**STAFF REPORT**  
**COMMUNITY DEVELOPMENT DEPARTMENT**

HEARING DATE: April 7, 2022  
 TO: Planning & Zoning Commission  
 FROM: Joseph Dodson, Associate Planner  
 208-884-5533  
 SUBJECT: H-2022-0005  
 Summertown Subdivision  
 LOCATION: Site is located at 3104 N. Venable, at the southeast corner of N. Venable Lane and W. Ustick Road, In the NW 1/4 of the NE 1/4 of Section 1, Township 3N, Range 1 W.

Preliminary Plat consisting of 23 residential building lots (9 single-family lots and 14 multi-family lots) and 3 common lots on approximately 13.8 acres of land in the TN-R zoning district (Traditional Neighborhood Residential), by Summertown, LLC.

B. Preliminary Plat (dated: January 2022)

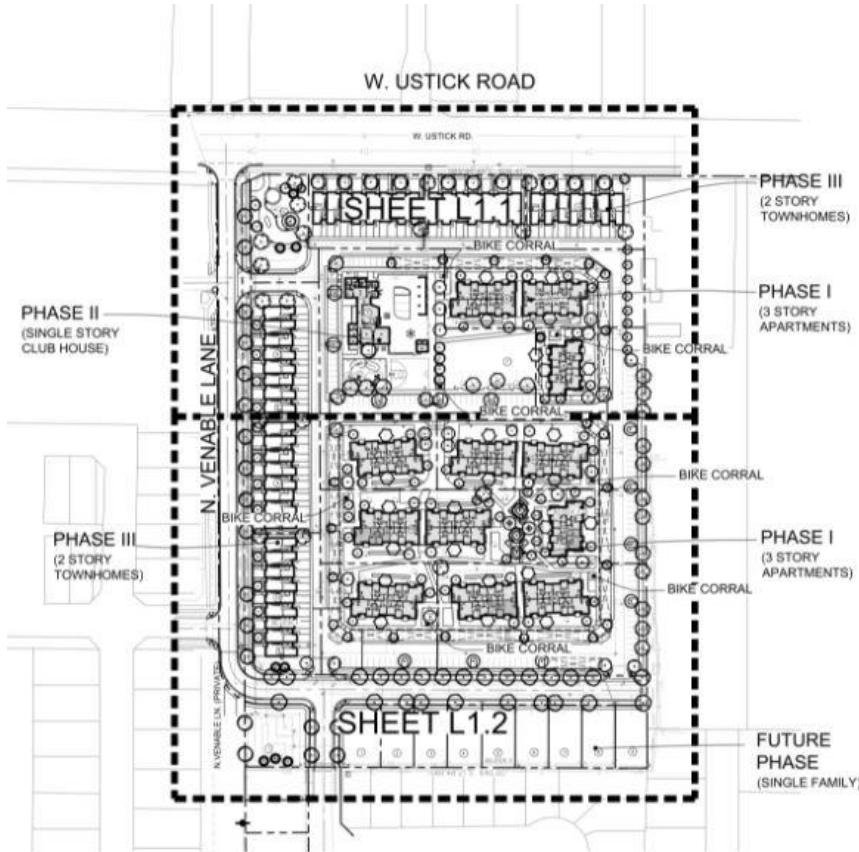
*Upon analysis of the submitted plat, it appears N. Venable Lane is being shown as a 29-foot collector street section for its entire length, from Ustick south to Wrangler Street connection point at the southwest corner of the project. Previous approvals allow Venable to be constructed with this reduced collector street section for a majority of its length but not in its entirety. According to ACHD, Venable should be constructed as 36-foot wide collector street section from Ustick and 245 feet south to the northern drive aisle connection across from the existing drive aisle connection to Venable for the Crossfield Apartments. It is unclear on the submitted plat if this condition of approval is being shown accurately. The Applicant should revise the plat to meet this condition of approval or provide written documentation that ACHD has approved a reduced street section for this area of the project.*

*Staff finds the previously approved project complies with the private street applicability standards as it is not a single-family development and all of the units front on or access green space rather than the street. Further, the drive aisles (private streets) are shown to be 26 feet wide with sidewalks adjacent to a majority of the parking stalls. UDC 11-3F-4 requires private streets to be a minimum of 24 feet wide and sidewalks are not required. Therefore, the Applicant complies with the minimum dimensional standards outlined in the UDC. In addition, the private street must be within a single platted common lot or constructed on a perpetual ingress/egress easement. According to the submitted plat, the private street is not within a common lot and is noted as being within an easement. However, this easement is not clearly depicted on the plat and a plat note has not been included noting its purpose. These items should be corrected with the final plat submittal. If these conditions of approval are met, Staff finds the*

*In addition to the 5-foot detached sidewalk along Venable, the Applicant is showing 4-foot wide sidewalk on the west side of the internal private street that runs north-south within the multi-family portion of the project (shown as N. Ridgebury Lane). Ridgebury Lane is shown with sidewalks on both sides of the private street but is not required by code, as noted in the previous section. In addition, the Applicant has some room within the building lot itself to adjust the property line and building setback to Venable because the TN-R zoning district allows a reduced setback when the units are alley-loaded—these multi-family units take vehicular access via Ridgebury Lane, an alley in its functionality, and main pedestrian access along Venable. **During pre-application meetings, Staff presented this issue and recommended the Applicant remove the western sidewalk along Ridgebury Lane and make minor building lot adjustments to construct the required multi-use pathway along the east side of Venable. Per the submitted plat, the Applicant did not make these revisions. In order to comply with the Pathways Master Plan, Staff is including conditions of approval consistent with these recommendations.***

*Furthermore, this multi-use pathway segment is shown to continue south through an adjacent County parcel (S1201214713) in the future. In order to allow for this to occur, a logical termination of the multi-use segment on the east side of Venable should occur so that a safe crossing location is attainable. The logical location for this would be at the northeast corner of Venable and Wrangler Street so it can be constructed at the southwest corner of this intersection should the county parcel redevelop in the future. Staff notes, the existing county residence takes access via Venable and will continue to do so until such time the property redevelops. After reviewing the existing conditions of the county parcel and the existing stub streets to its property, Staff anticipates this existing access being removed and becoming an area of open space and the multi-use pathway segment. Therefore, setting up the correct locations of the multi-use pathway stubs with this project to the county parcel is significantly important. Staff **recommends the Applicant** construct a segment of the City's multi-use pathway within Lot 1, Block 2.*

Detached sidewalks are proposed along the internal local streets (W. Wrangler and the Ridgebury Lane extension) and along N. Venable, the collector street along the west boundary. There is existing 5-foot wide sidewalk along the west side of Venable that was constructed with other projects. According to the submitted plat and landscape plans, the Applicant is proposing a minimum of 8-foot wide sidewalks along all public streets. In addition, the Applicant is showing 4-foot and 5-foot wide attached sidewalks along the private streets within the multi-family area of the project. All proposed sidewalks meet UDC standards. However, the sidewalk along the east side of N. Venable should be constructed as a 10-foot multi-use pathway, as discussed in the section above.

*Staff notes the existing approvals do not account for the parkways along W. Wrangler and the Ridgebury Avenue stub. So, the amount of qualified open space is in fact higher than previously noted—with the final plat submittal, the applicant should revise the open space calculations and include these parkways.*

3. The Applicant shall comply with all ACHD conditions of approval—depict N. Venable Lane as 36-foot wide collector street section from Ustick and 245 feet south to the northern drive aisle connection or show proof that ACHD has approved a reduced street section for this area of the public street.

11. The submitted preliminary plat, dated January 2022, shall be revised as follows prior to Final Plat submittal:
  - a. Depict the required landscape buffers along Ustick and Venable via a landscape easement—ensure minimum width of 25 feet along Ustick is noted despite not being on property (measured from back of curb).

- b. Add a plat note referencing the required license agreement with ACHD for the portion of the landscape buffer in the public right-of-way, per UDC 11-3B-7C.5.b.

- c. Construct a 10-foot wide multi-use pathway on the east side of N. Venable Lane and within Lot 1, Block 2 consistent with the Pathways Master Plan.

- d. Remove the sidewalk on the west side of N. Ridgebury Lane (east side of Lots 8, 9, & 14, Block 1) to move the units east to accommodate the multi-use pathway on the east side of N. Venable.

- e. Depict the private streets within a singular common lot or clearly depict the private street easement on the plat, in accord with UDC 11-3F-4A.
  - f. Add a plat note stating “No direct lot access is permitted to W. Ustick Road or N. Venable Lane.”
12. The submitted landscape plan, dated December 27, 2021, shall be revised prior to final plat submittal:
- a. Revise the landscape plans consistent with the preliminary plat revisions noted above in condition VIII.A.8.
  - b. Add data to the landscape plans showing compliance with UDC 11-3B-7C for the proposed parkways.
  - c. Clearly depict the required street buffers along W. Ustick Road and N. Venable Lane.
13. Placeholder for additional conditions if needed.

C. Landscape Plan (date: 12/27/2021)

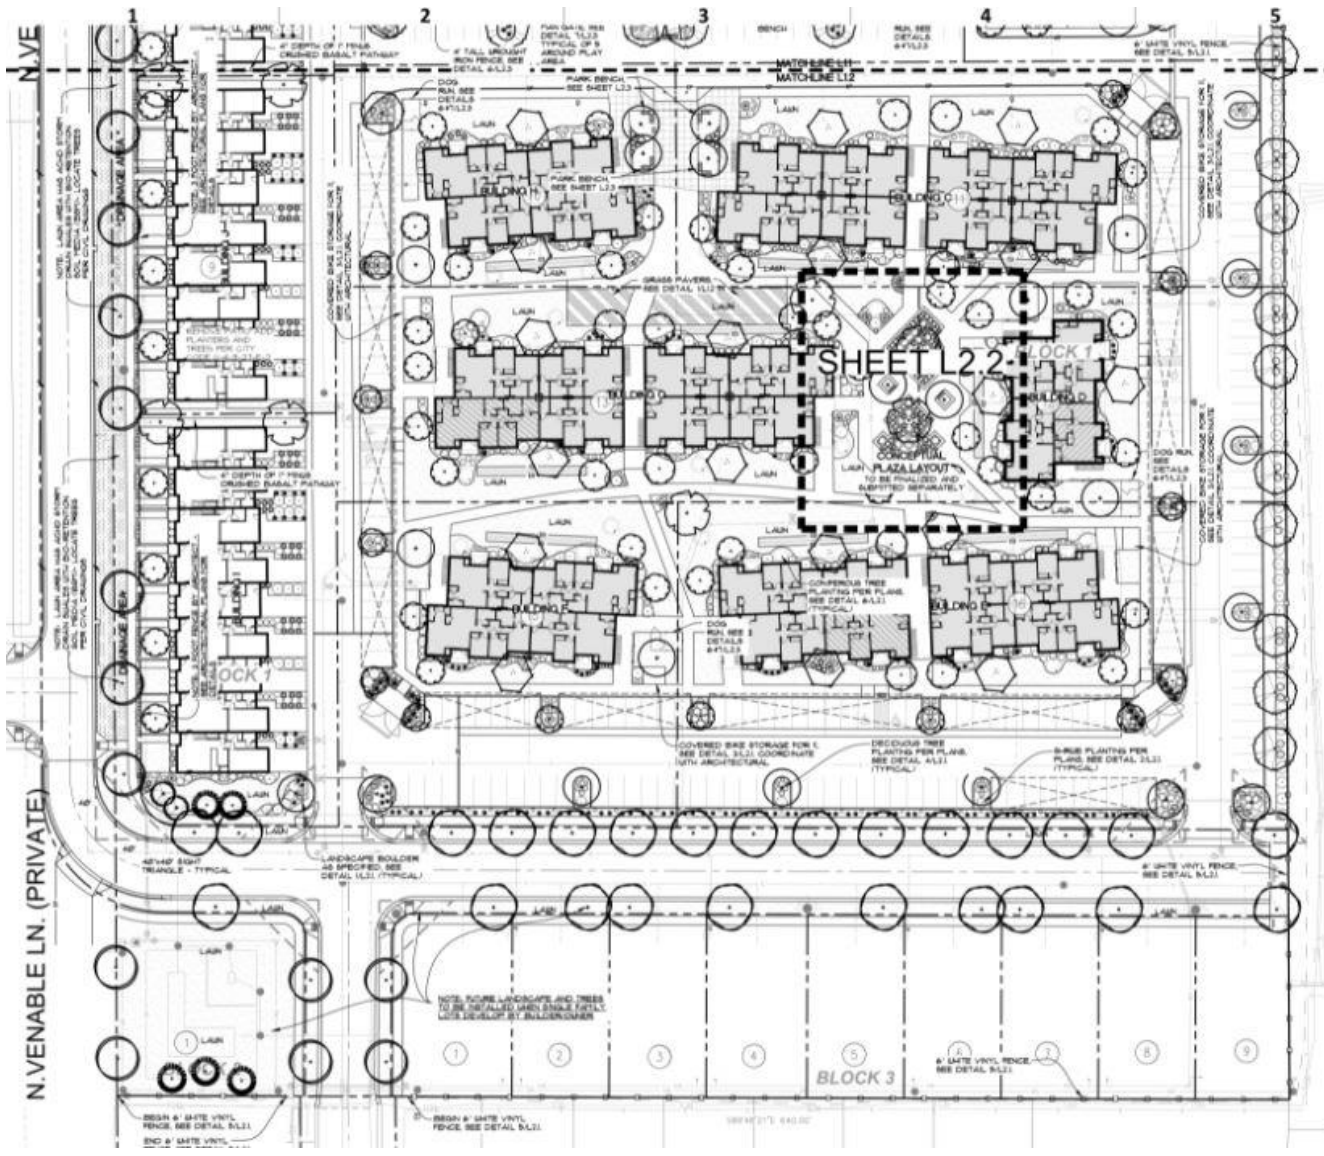
8-foot wide parkways with street trees are shown along both sides of the proposed local streets (W. Wrangler and N. Ridgebury). **All parkways within the site adjacent to detached sidewalks shall be landscaped per the standards listed in UDC 11-3B-7C.** According to the submitted landscape plan, there appears to be the correct number of trees but the table does not accurately describe the parkway along W. Wrangler and instead labels it as perimeter landscaping. With the future final plat application,

the Applicant should correct this and list this parkway within the landscape table and show the correct number trees.

*There is existing landscaping and detached sidewalk along Ustick Road and the Summertown property line does not extend all the way to the back of curb, where the required buffer is to be measured from per the UDC. Thus, the entire 25-foot buffer is not required to be solely on this property but the Applicant should do the following for clarity: 1. Note on the plat that the remaining buffer area is within ACHD right-of-way along Ustick consistent with the UDC, and; 2. Depict and label the full buffer width on the landscape plans. Including these two items will create transparency on both sets of plans moving forward to plat recordation. Further, the Applicant should enter into a license agreement with ACHD to landscape the right-of-way area consistent with City code.*
